OFFICIAL COORDINATION REQUEST FOR NON-ROUTINE OPERATIONS AND MAINTENANCE

TITLE- 21DET01 Detroit Dam IRRM Temporary Pool Restrictions

PROJECT- Detroit Dam

Figure 1. Proposed IRRM restrictions at Detroit Dam

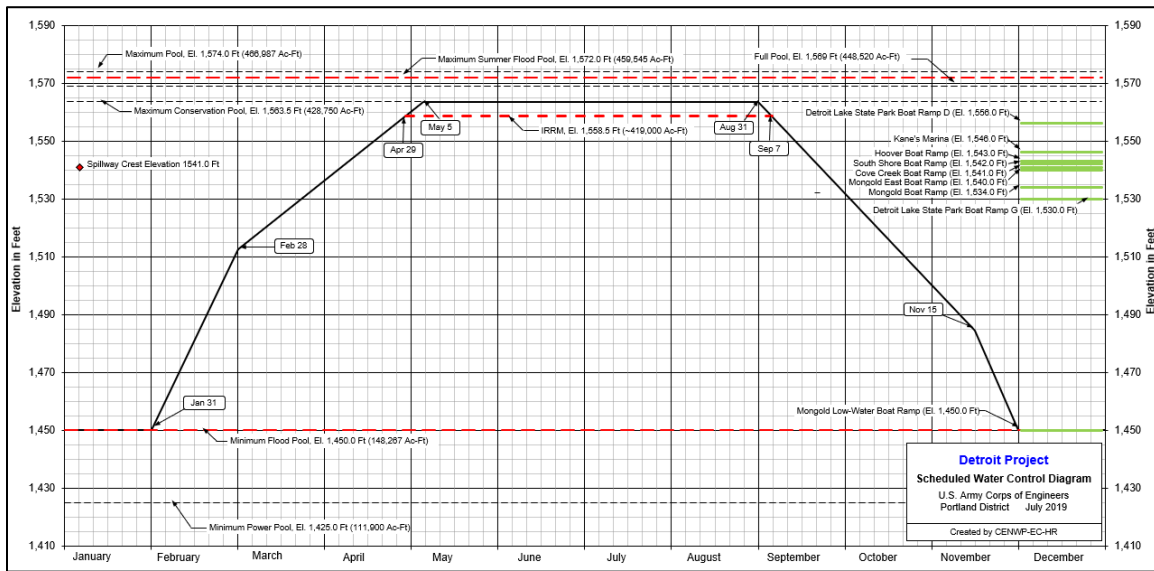
Due to the reduced availability of spill at the lower reservoir elevation, ODFW requests the USACE model initiating spill earlier in the season to determine if it will reduce the amount of warm water in the reservoir in the fall and if the earlier spill will improve the ability to meet downstream temperature targets. If earlier spill can achieve these objectives, it should be considered as a management option.
